**Addendum (Revision 2) to Remedial Action Options Report (RAOR)  
and Pre-Design Sampling Work Plan - Connell Aluminum Properties, LLC  
Former Koppers Tar Plant and Wabash Alloys Site  
9100 S. 5<sup>th</sup> Avenue, Oak Creek, WI 53154  
BRRTS# 02-41-553761, FID#241379050  
Connell VPLE BRRTS #:06-41-560068**

September 28, 2021

**City of Oak Creek Utility Corridor Lot 1  
9170 South 5<sup>th</sup> Avenue, Oak Creek, WI 53154  
BRRTS#: 02-41-561425, FID #:341074470  
VPLE BRRTS#: 06-41-561426**

**FIGURE 2**  
**FIGURE C40 (REV. SI REPORT)**

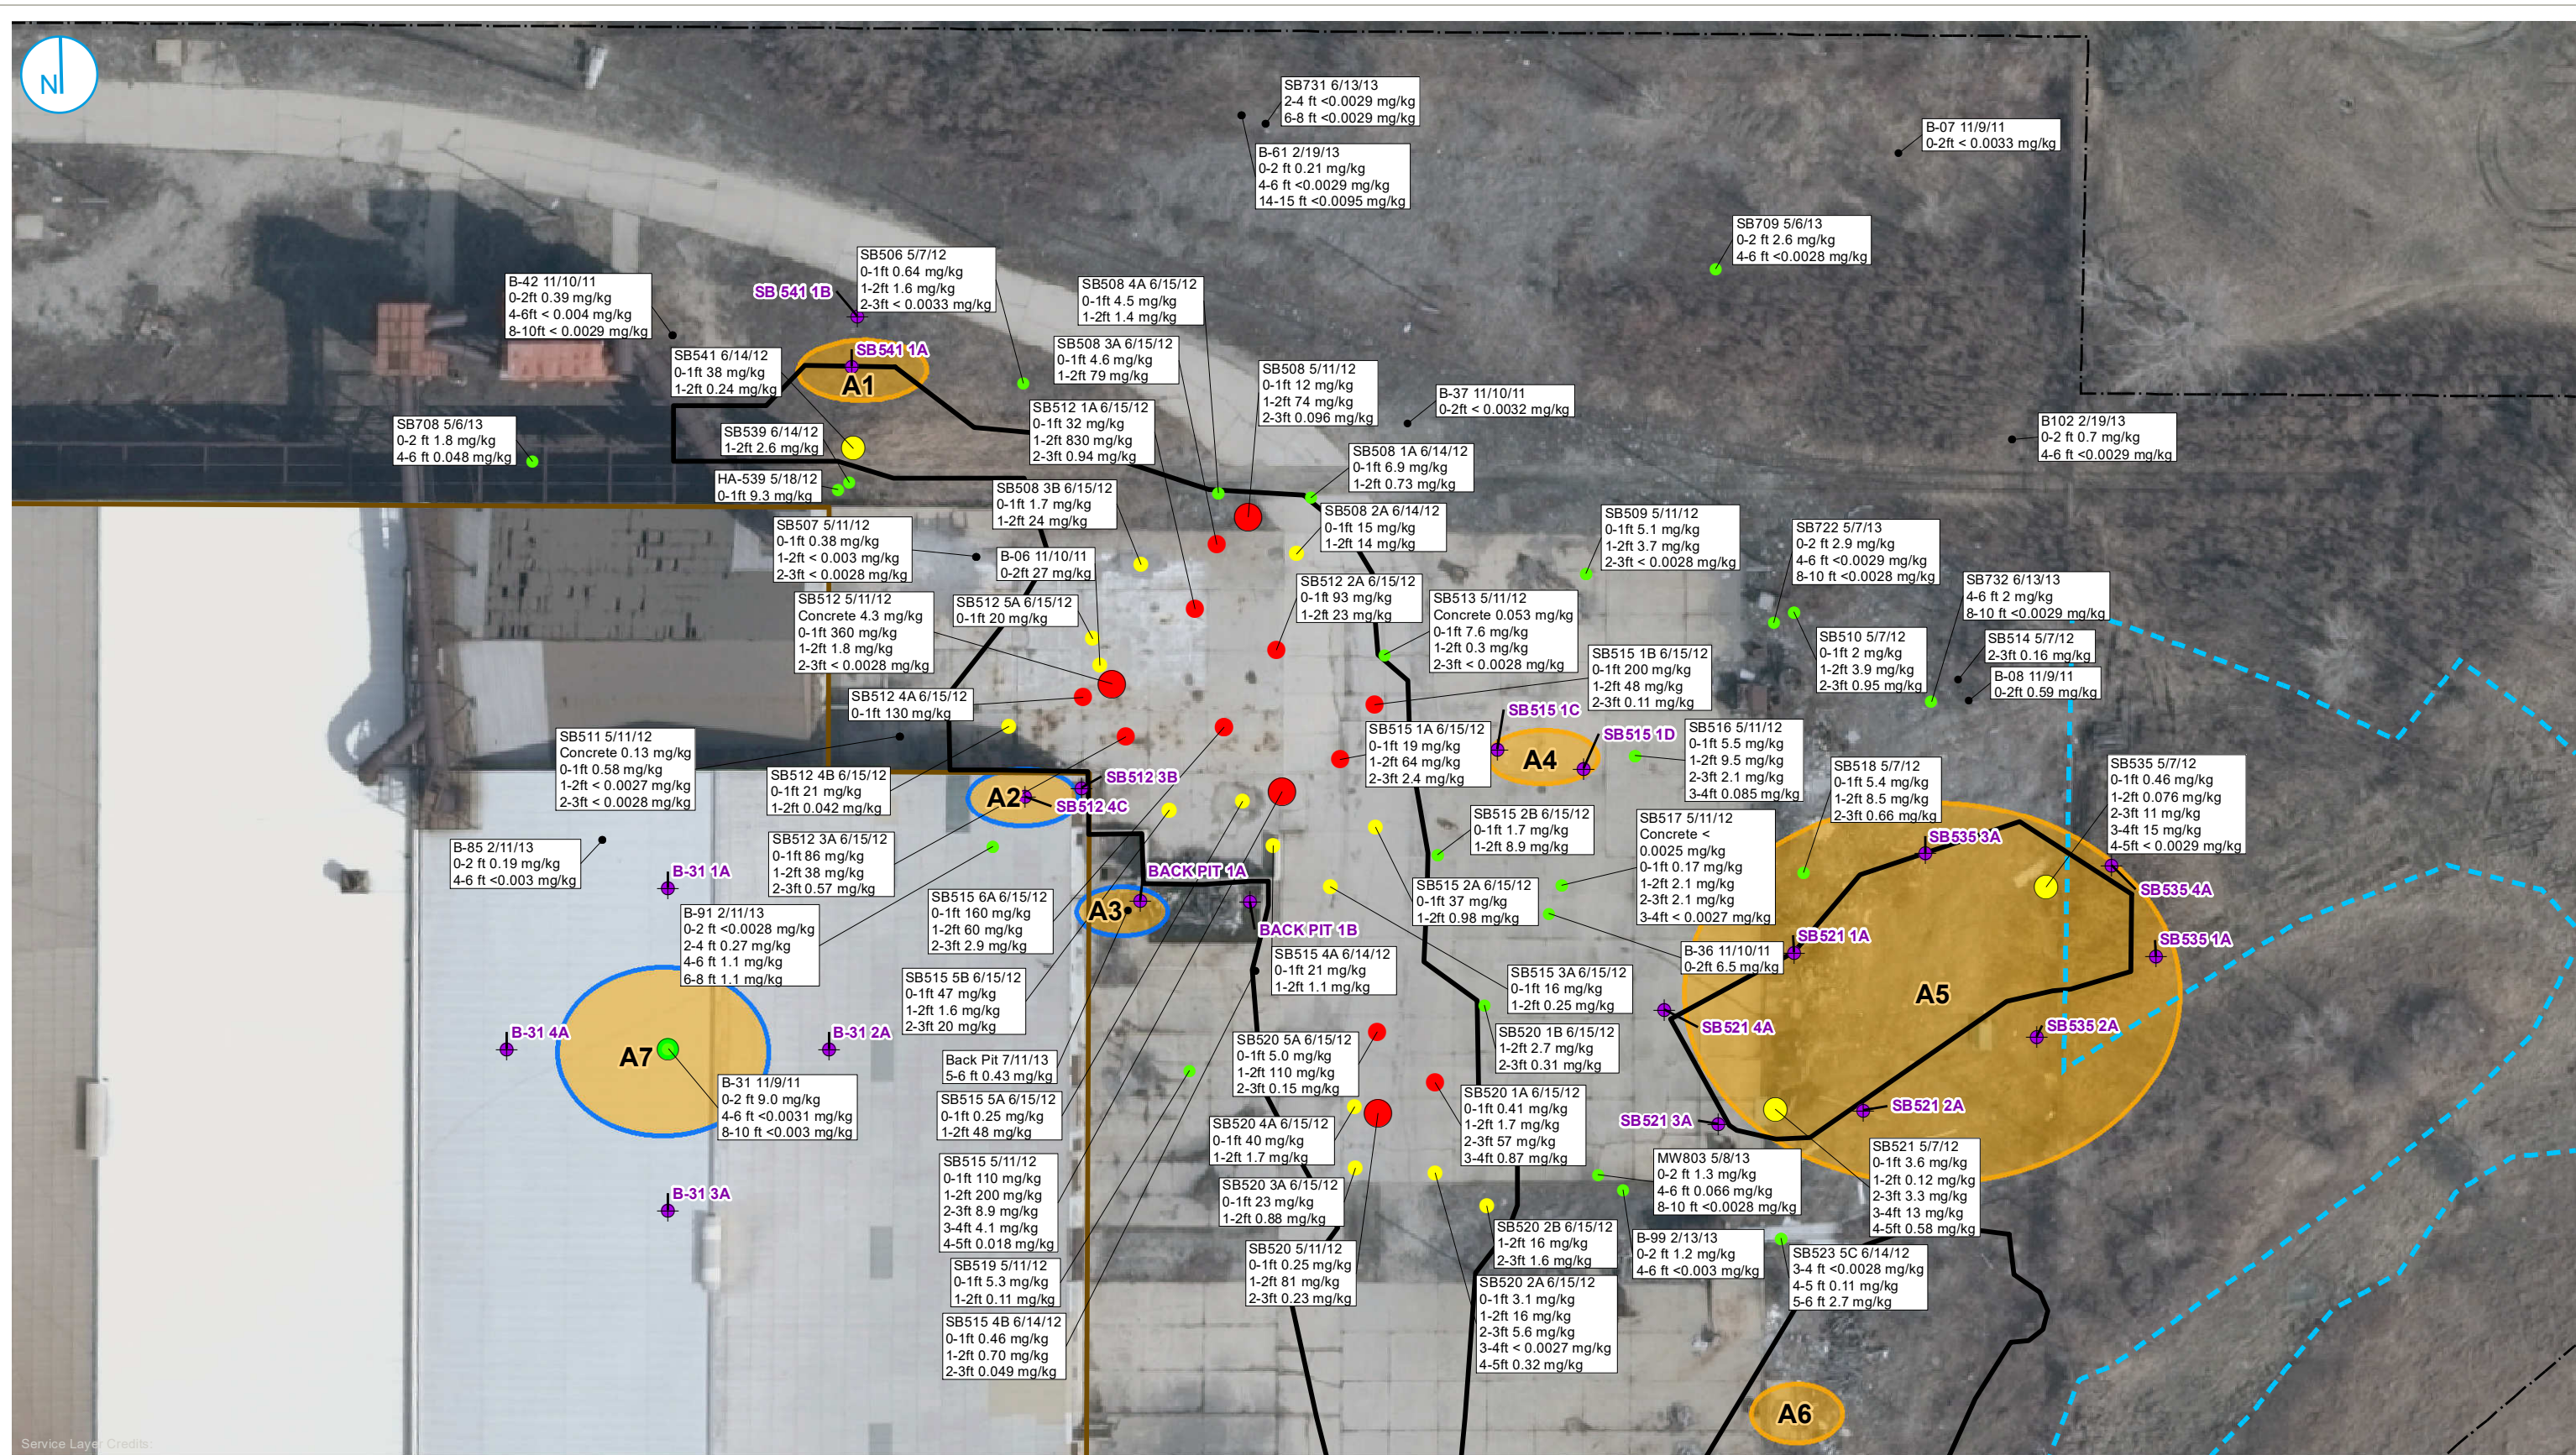
- Figure 2 – Revised Figure C40 SI Report - PCB Soil Data – North Yard TSCA Area for purposes of showing more specifically the additional PCB sampling locations related to comments A1 through A5, and A7.

**FIGURE 3**  
**FIGURE C41 (REV. SI REPORT)**

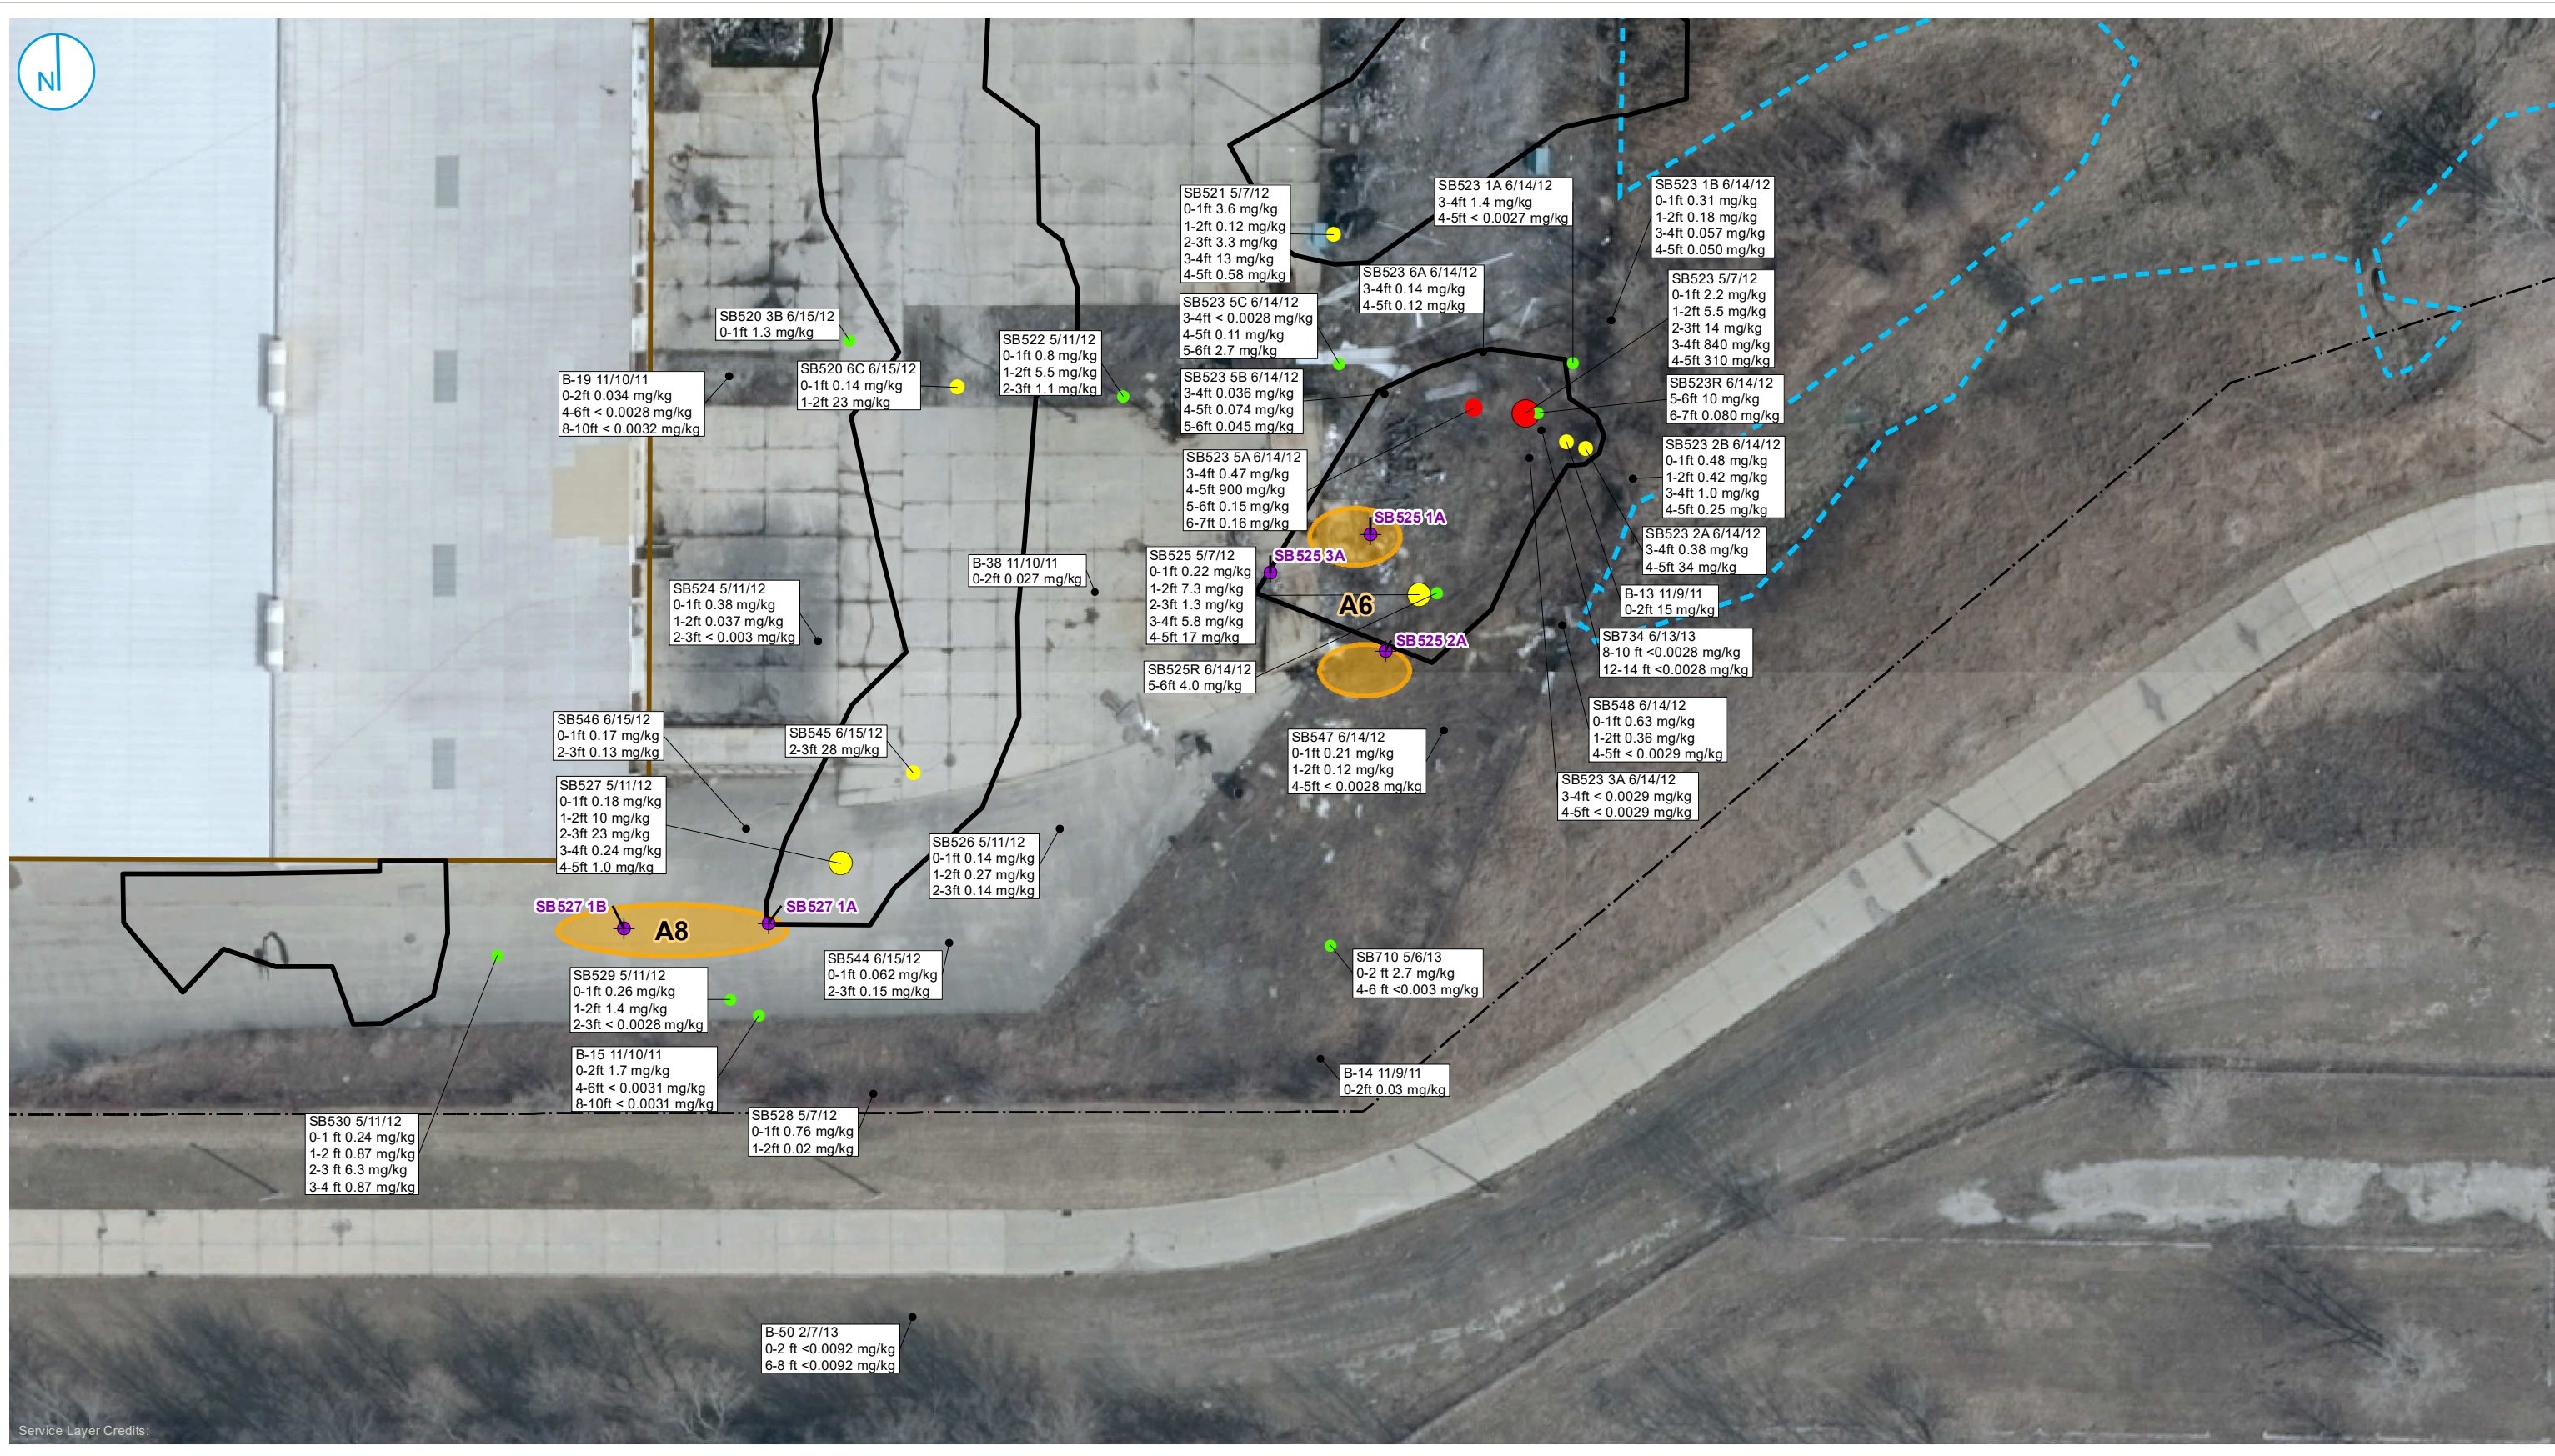
- Figure 3 – Revised Figure C41 SI Report – PCB Soil Data – South Yard TSCA Area for purposes of showing more specifically the additional PCB sampling locations related to comments A6 and A8.

**FIGURE 4  
FIGURE C42 (REV. SI REPORT)**

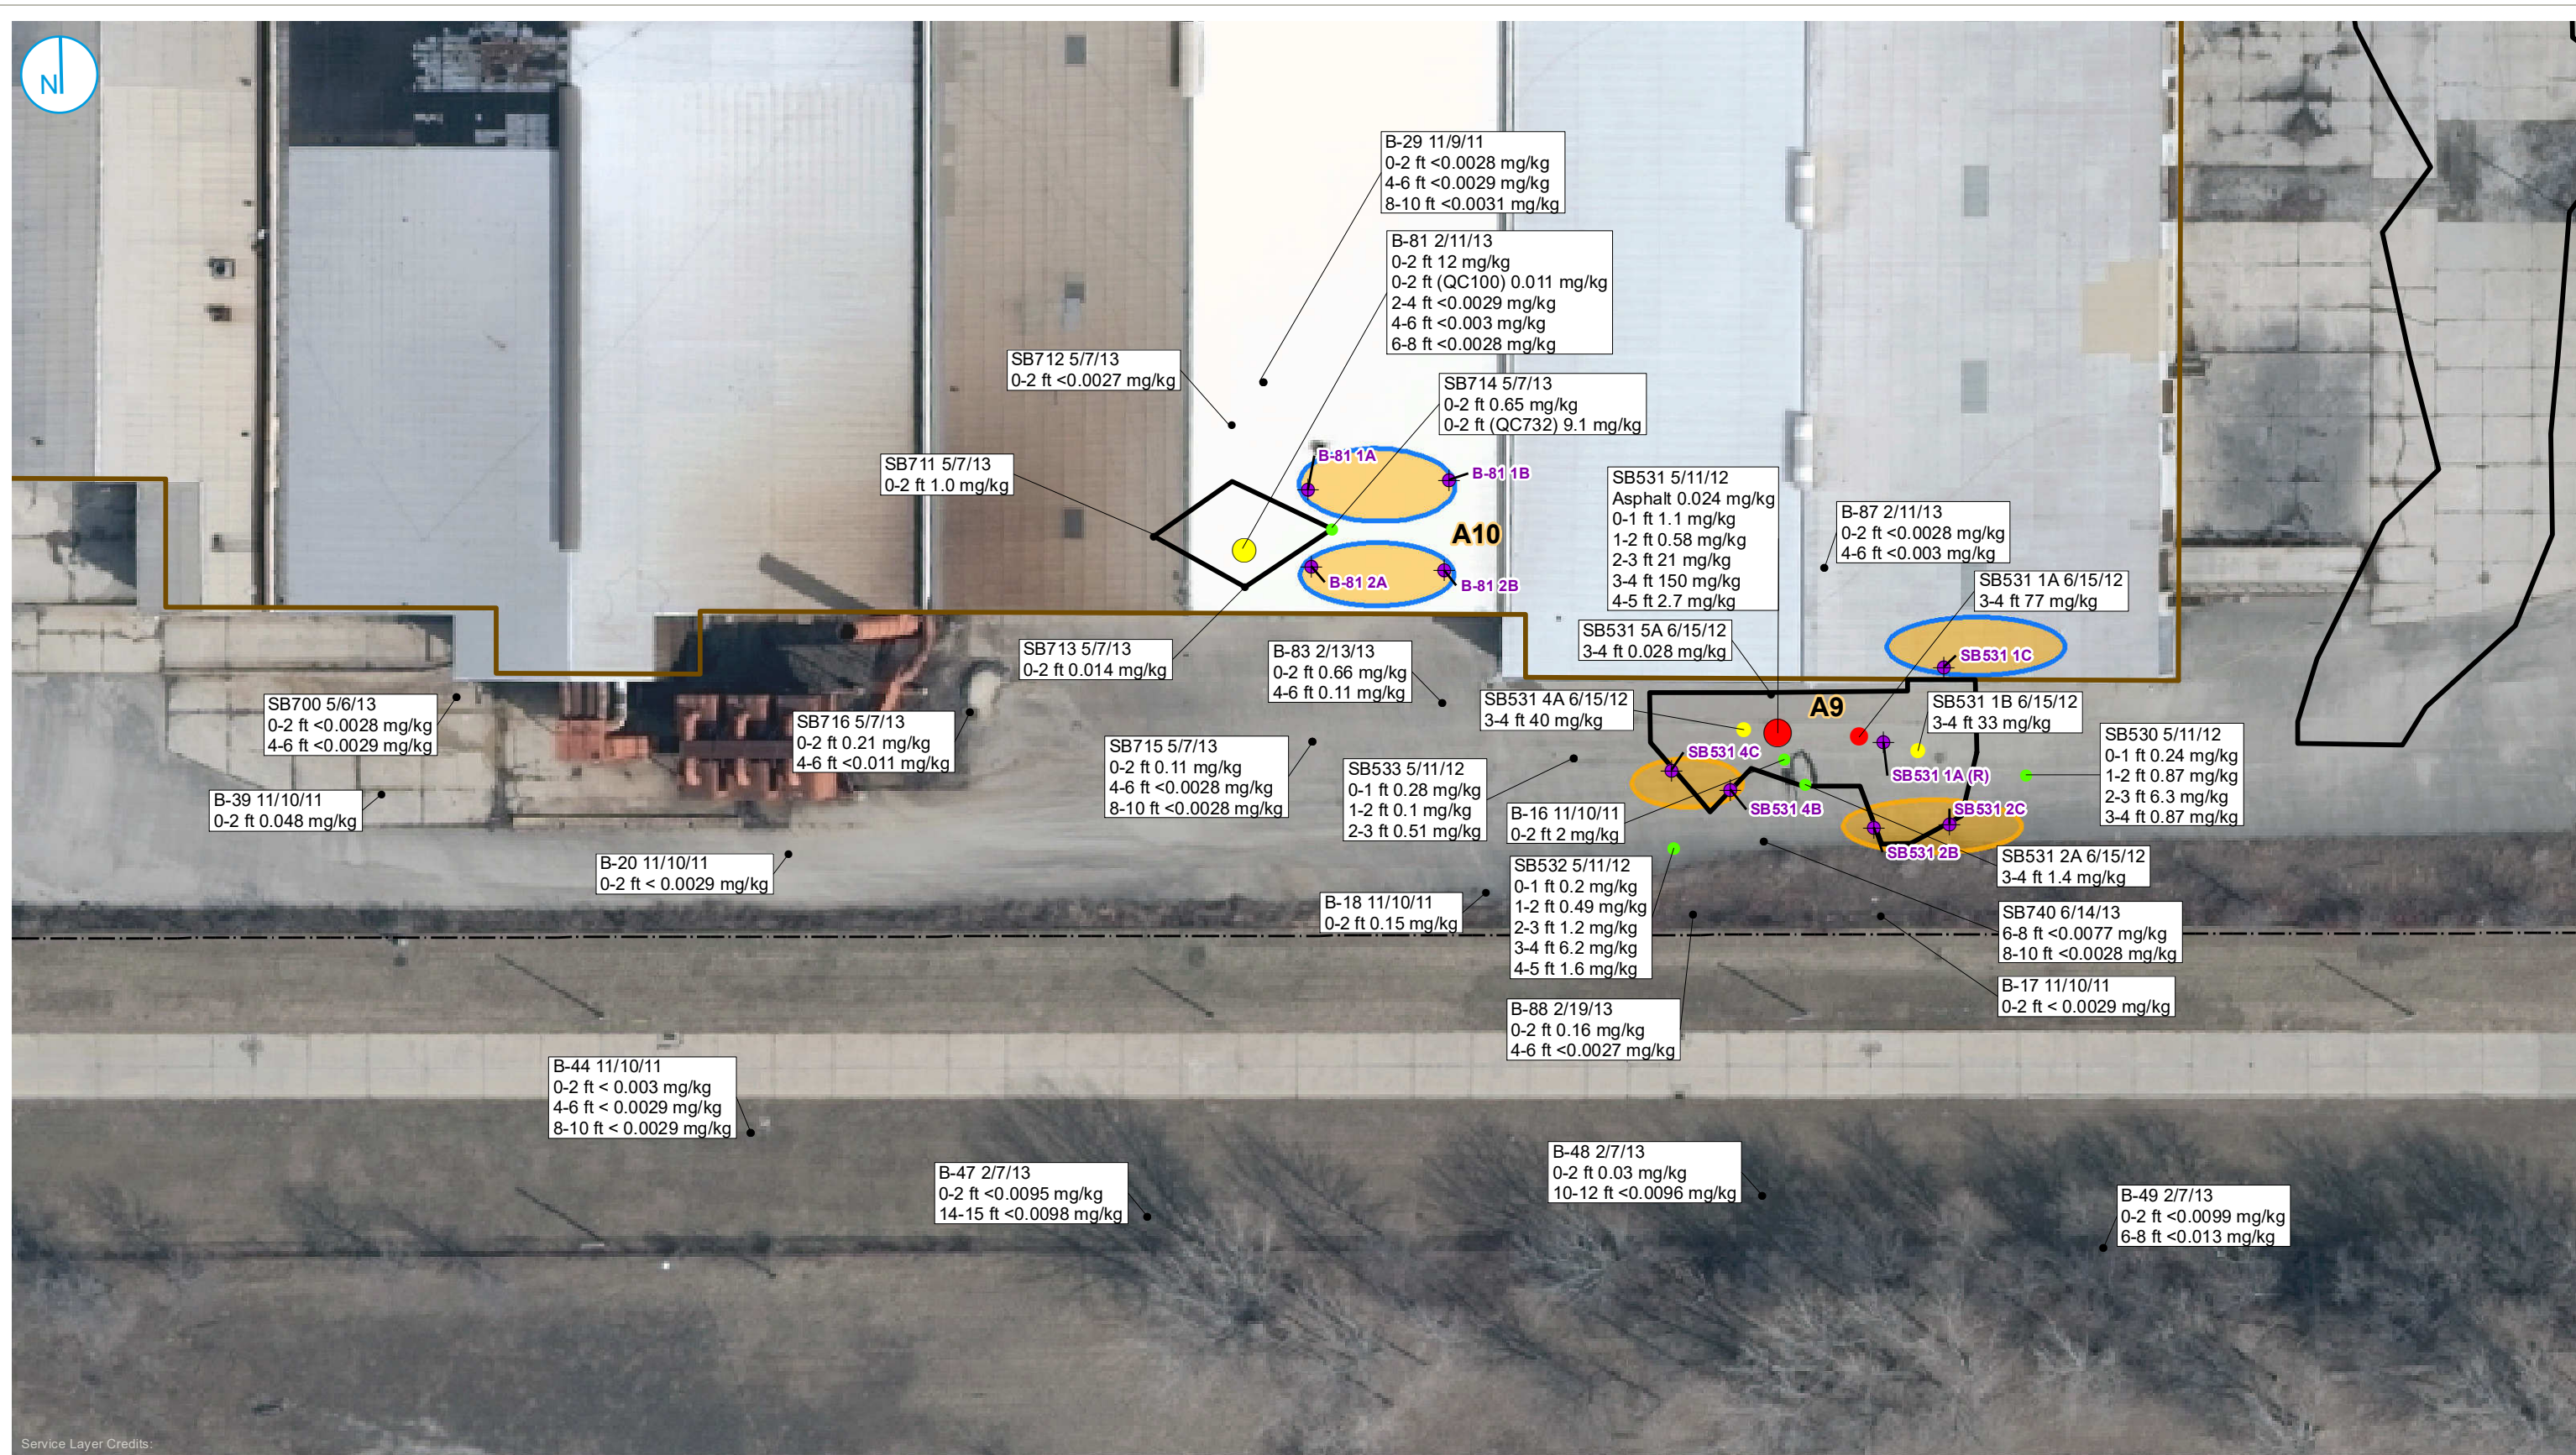
- Figure 4 – Revised Figure C42 SI Report – PCB Soil Data – South Exterior TSCA Area for purposes of showing more specifically the additional PCB sampling locations related to comments A9 and A10.
